P02 Changes incorporated as per CMT comments GP MH HG 23/01/2019

**UCLH
Phase 5 ENT Treatment Centre**

**Planning MMA Gordon Mansions
Elevation**

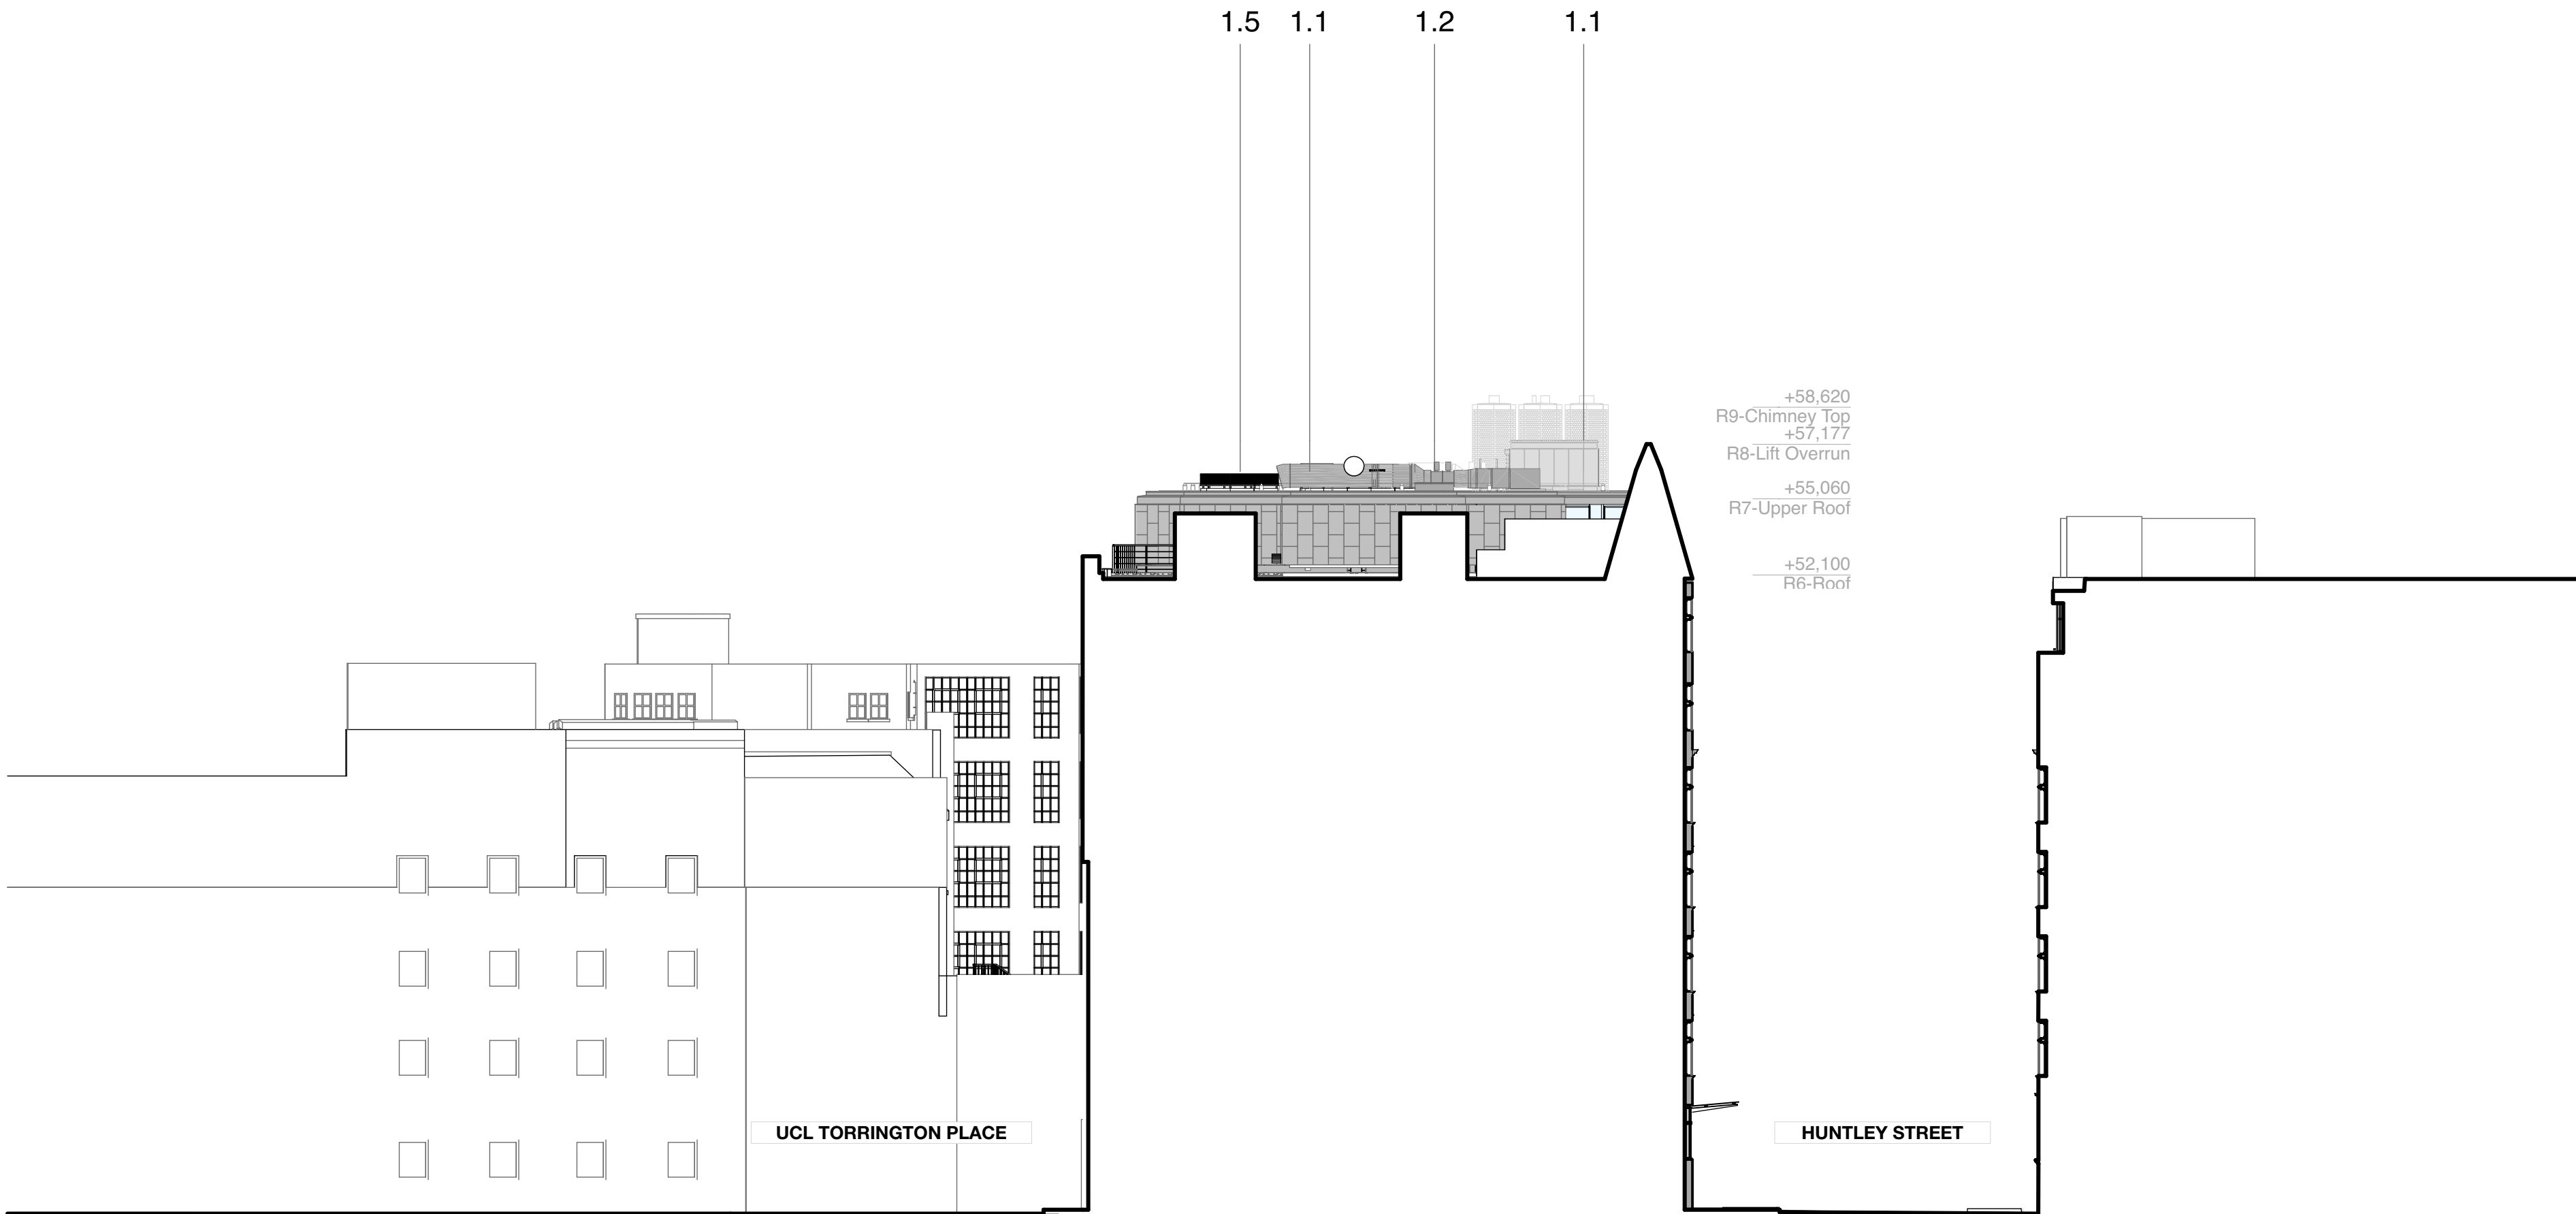
- 1.1 - Lift overrun removed
- 1.2 - South Core smoke depressurisation duct reconfigured
- 1.3 - Guardrail added to access hatch for improved safe access

- 1.4 - Toilet extract flue added
- 1.5 - Position of PVs reconfigured and profile lowered
- 1.6 - Removal of access door through glass balustrade
- 1.7 - Addition of housing for North Core smoke depressurisation duct

- 1.8 - Chimney flues added
- 1.9 - Escape door changed to flat metal panel doors to provide thermal performance
- 1.10 - Door arrangement to meet UKPN requirements

- 1.11 - Sheffield Hoop bike stands added
- 1.12 - Mullions added due to glass panel size restrictions
- 1.13 - North Core smoke depressurisation duct reconfigured

- 1.14 - Roller shutter amended with open grill sections to provide required fresh air flow
- 1.15 - Minor amendments to access ladders
- 1.16 - Bollards added to protect pavement grill

- 1.17 - Dry Riser moved
- 1.18 - Configuration of panel joints amended for buildability
- 1.19 - Satellite dish & aerial added
- 1.20 - Louvre increased to provide required air flow
